P5025A-04

# Information Only Service Note

# P5025A Keysight Streamline USB Vector Network Analyzer

False alarm on self-test failure on firmware revision of A.13.40.02 - DDR3 memory removal

#### Self-test

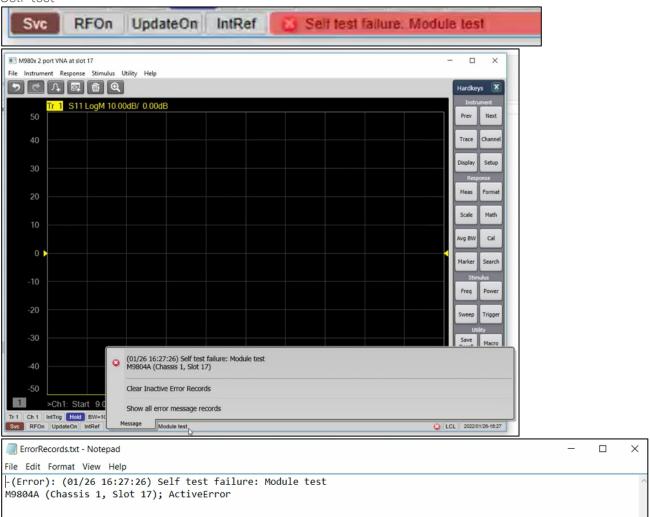
The on board DDR 3 memory in VNA is not in use since its release. With the removal of DDR 3 memory IC on newer P502xA VNA, right after firmware is launched, false alarm (self-test failure) will be reported as shown. This has no impact to VNA performance and specifications.

Similarly, firmware will report a false failure in Operator check. Shown are the error messages example on VNA firmware UI.

For users with firmware revision of A.13.40.02, Update firmware to revision A.13.70.02 or newer to resolve this false alarm on self-test.
